SmartCraft Clean Power Harness

Models Affected

53621

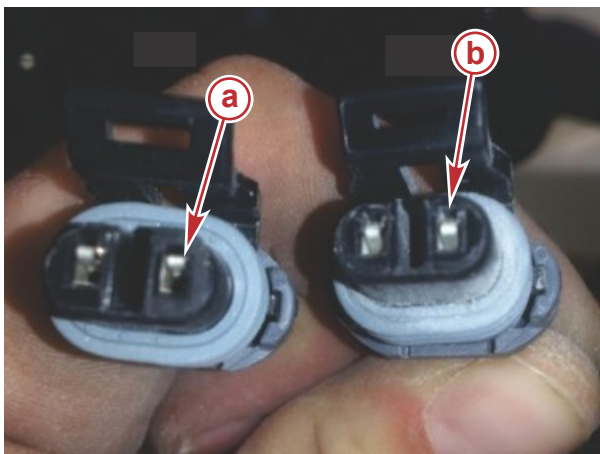
During the manufacturing process some of the female terminals in the clean power 2-pin connector were spread too wide, creating the possibility for either an intermittent electrical failure (occasional engine shutdown), or a complete break in power (engine cannot start, or started then stopped and cannot be restarted). For connectors that were not spread too wide during the manufacturing process, normal electrical component performance and reliability is expected. For connectors that were spread too wide there is a high probability that one of the two electrical failures (intermittent or complete open circuit) will occur either immediately on attempted engine start-up, or very soon thereafter.

a - Bad
b - Good

Correct if any of the conditions described in the **Situation** section are reported by the customer, or observed during setup, inspect the battery connections and replace any clean power harness in the date codes listed if the conditions mentioned in this bulletin are present. Replace with P/N 888416T04.

NOTE: Do not attempt to repair the harness. Replace clean power harness complete.
